Access Compliance Report Public Rights-of-Way (Curb Ramps)

Intersection ID: 16872 Main Street: PRESSLEY RD Cross Street: S_TRYON_ST Location: ADA ID: AD9285580140 Ramp Type: ParaDiag Initial Pass/Fail: Fail **Overall Compliance: No** Severity Score: 13.75

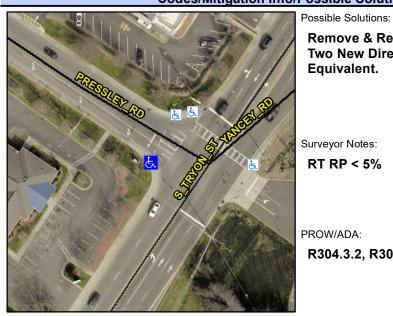
Remove & Replace Curb Ramp With Two New Directional Ramps or Equivalent.

RT RP < 5%

R304.3.2, R304.5.3
